**IN THE MATTER** of the hearing for Plan Change 13 – Uplifting  
Deferred Zones of a submission by Papamoa TA  
Limited Partnership

**STATEMENT OF EVIDENCE OF BRONWYN RHYND**

**To:** Papamoa TA Limited Partnership  
**From:** Tony Wang – Engineer  
**Reviewed:** Bronwyn Rhynd – Director  
**Re:** **Stormwater strategy review - T6 -164 St Leger Road, Te Awamutu**

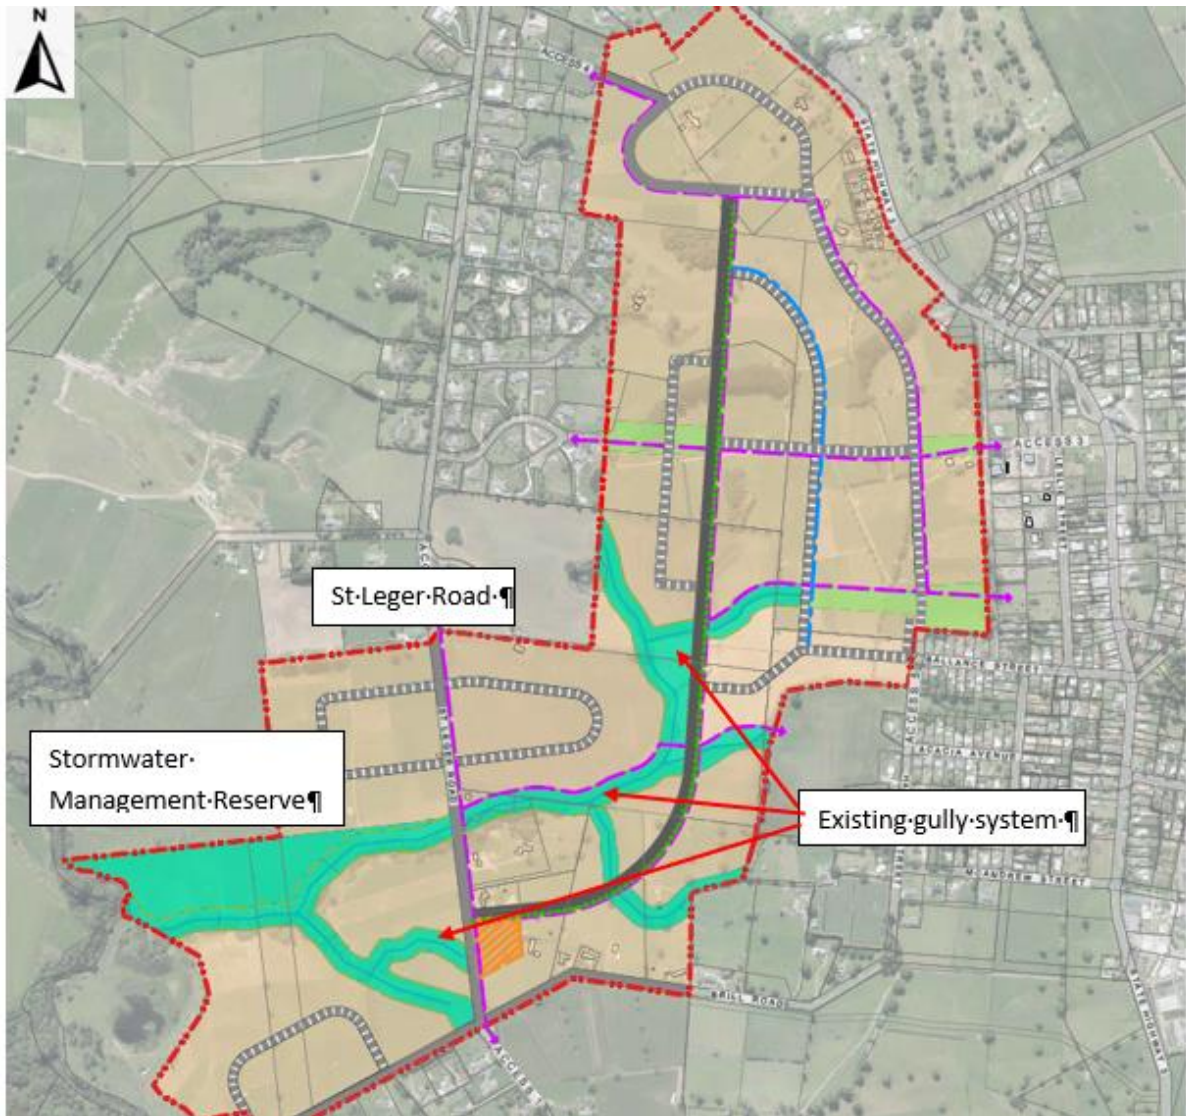
3.4 In applying the above requirements, or objectives, to the area west of St Leger Road and north of the Puniu River tributary has highlighted that the structure plan stormwater reserve located in the far western sector of growth cell T6, is either redundant or unable to be utilized to its full extent.

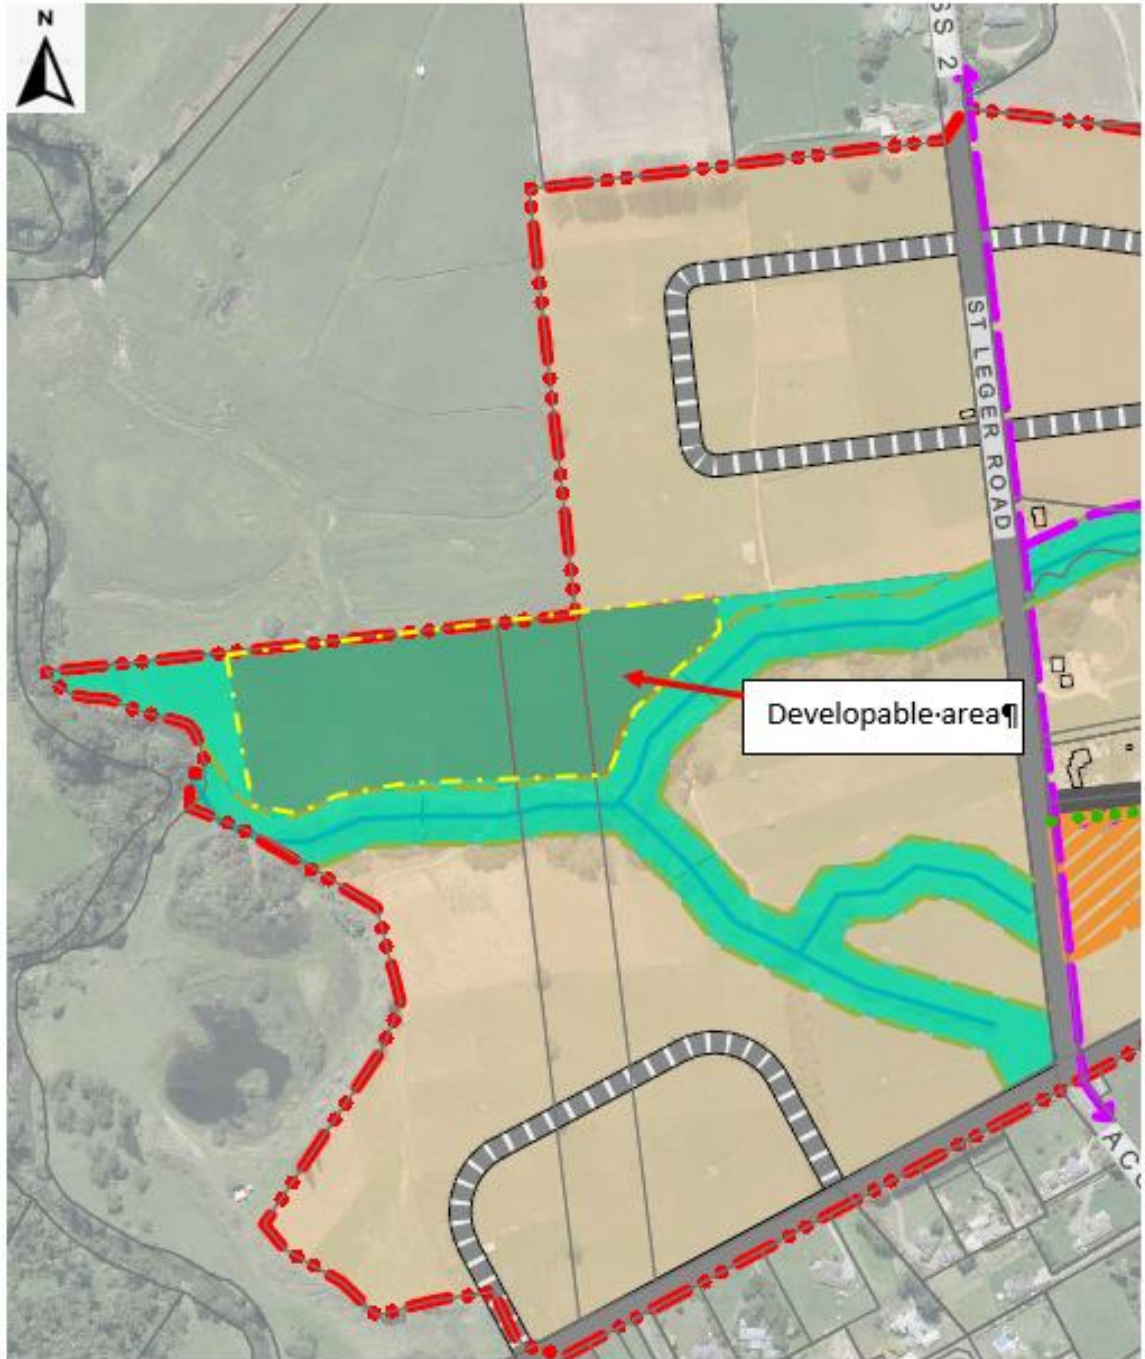
- 5.1 A review of the structure plan's stormwater management proposed for the sub catchment west of St Leger Road and north of the tributary highlights the following:
- the stormwater reserve is located in an area which is elevated and unobtainable for the majority of the Growth Cell T6.
  - stormwater management could be achieved "at source and on lot" for this sub catchment

- 5.2 Based on these findings this area could have the same development potential as the areas south of the tributary and west of St Leger Road.
- 5.3 Therefore, the land currently assigned as a stormwater reserve, as presented below, can potentially be developed into future residential subdivision.

5.4 Alternatively, there could be a communal stormwater reserve applied for this subcatchment to accommodate the stormwater treatment and extended detention requirements for this sub catchment only. The area required for a communal stormwater reserve is in the order of 1.6ha (which is approximately 10% of the sub catchment area) and illustrated in the figure below.

Figure 1: T6 structure plan

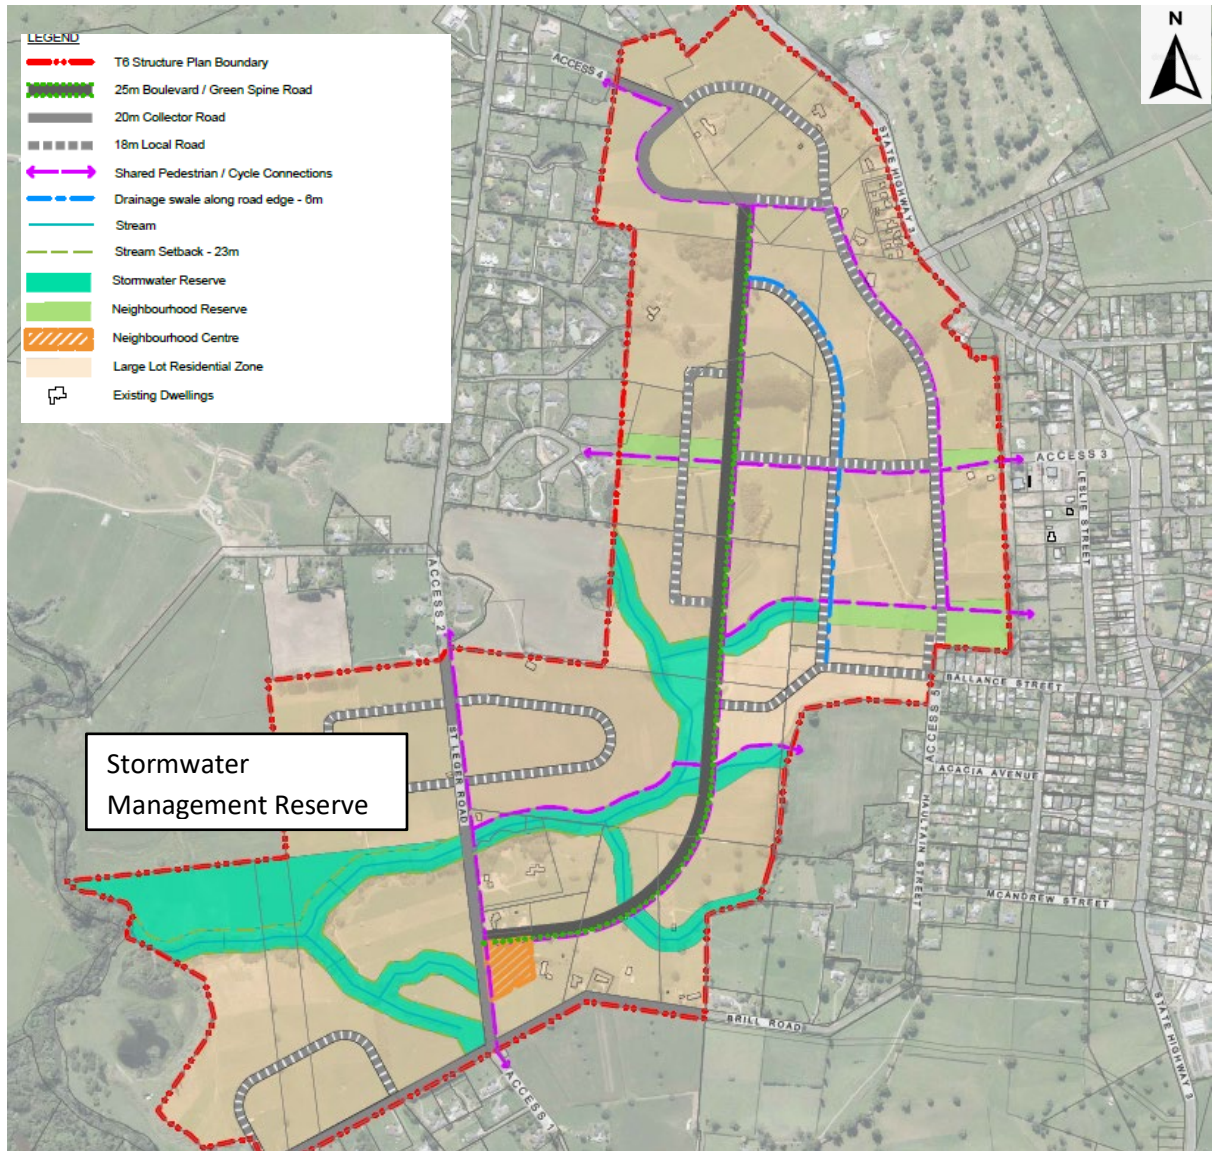
The T6 structure plan has been developed with stormwater reserves and conveyance systems to support the total growth cell. The proposed stormwater management areas which include reserves and stream setbacks is shown in Figure 1.

Figure 2: Channel and Gully Locations

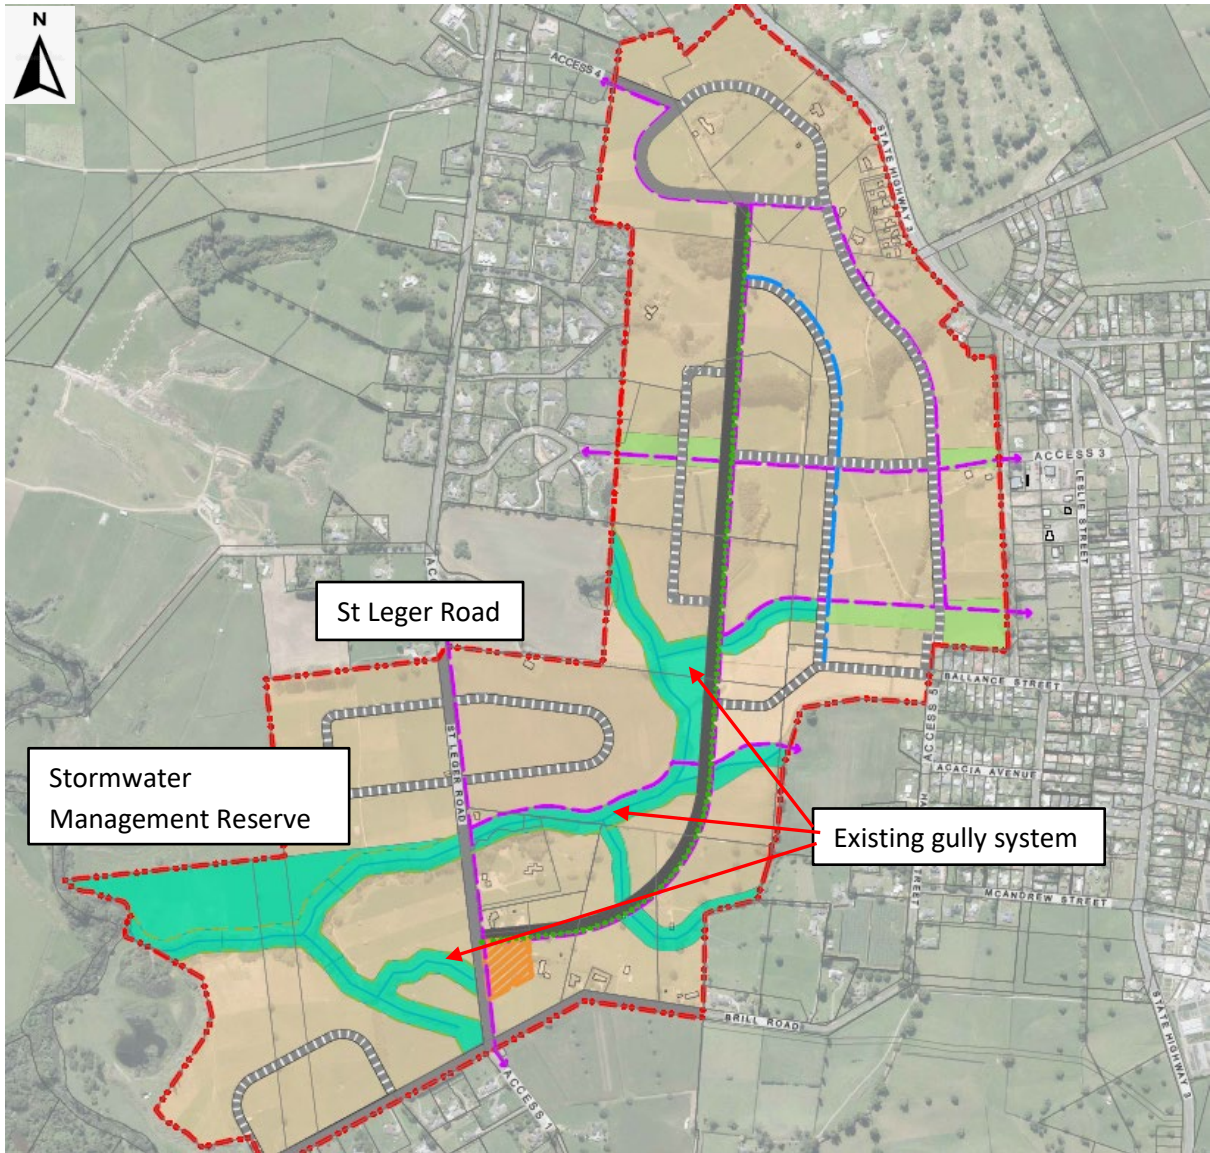
The existing gully and proposed channel system are shown in Figure 2. The existing gully and channel are shown as intercepting and conveying flow from within the T6 growth cell towards the Puniu Stream. There is no connection as to how the stream and gully system will utilise the stormwater reserve as the following aspects have not been considered:

- Stormwater management reserve is elevated above the channel and gully system
- The reserve can only receive runoff from the sub catchment west of St Leger Road and north of the tributary due to topographical constraints

In addition should there be a system that utilised a stormwater reserve (should the topography allow) then the primary system would bypass tributary and the resultant starvation of the tributary would occur.

The biggest concern with the location of the stormwater management reserve is that it is elevated above the adjacent channel and gully, see Figure 3. Therefore, it is considered difficult and ineffective to convey the flow across the St Leger Road and towards the stormwater management reserve.

Figure 5: Communal Stormwater reserve

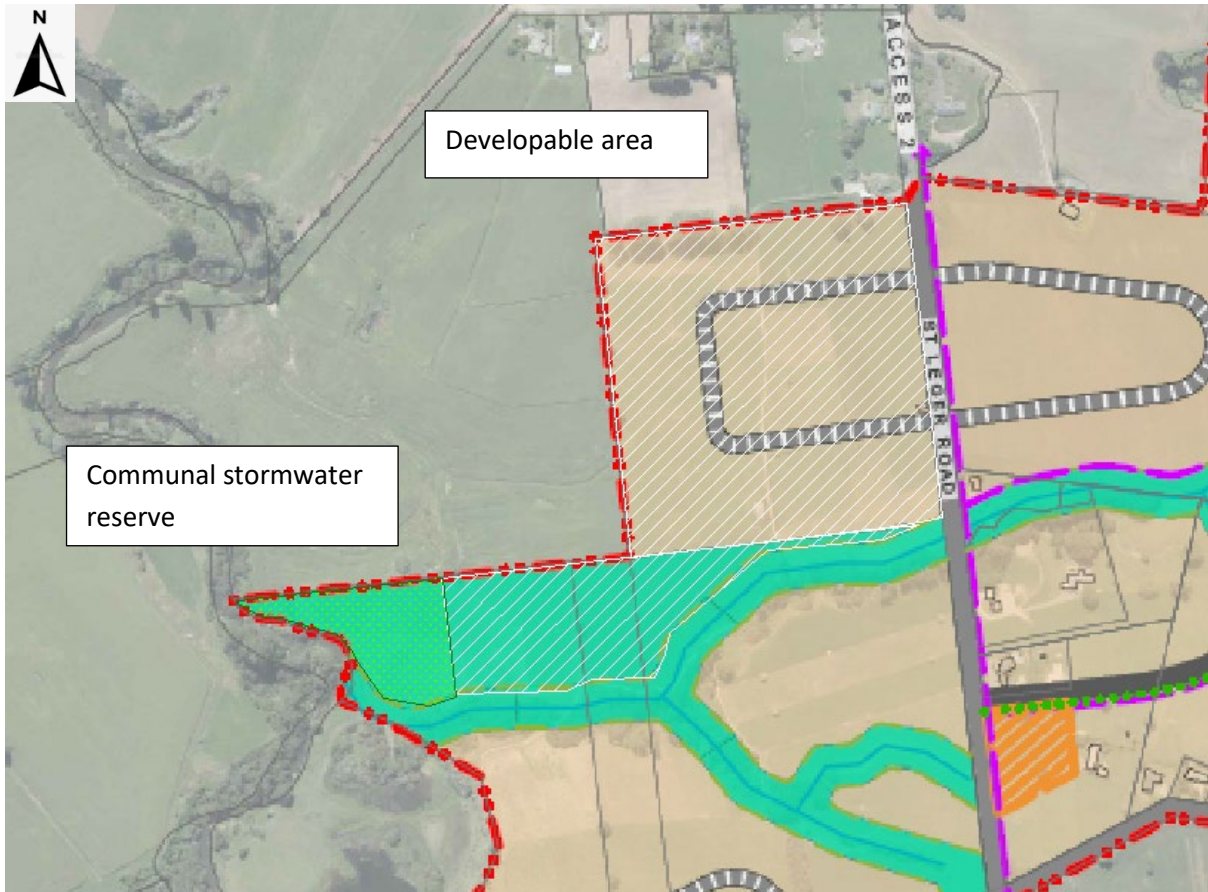
Alternatively, there could be a communal stormwater reserve could be applied for the subcatchment west of St Leger Road and north of the tributary to accommodate the stormwater treatment and extended detention requirements for this sub catchment only. This is in the order of 1.6ha (which is approximately 10% of the sub catchment area) and illustrated in the figure below.
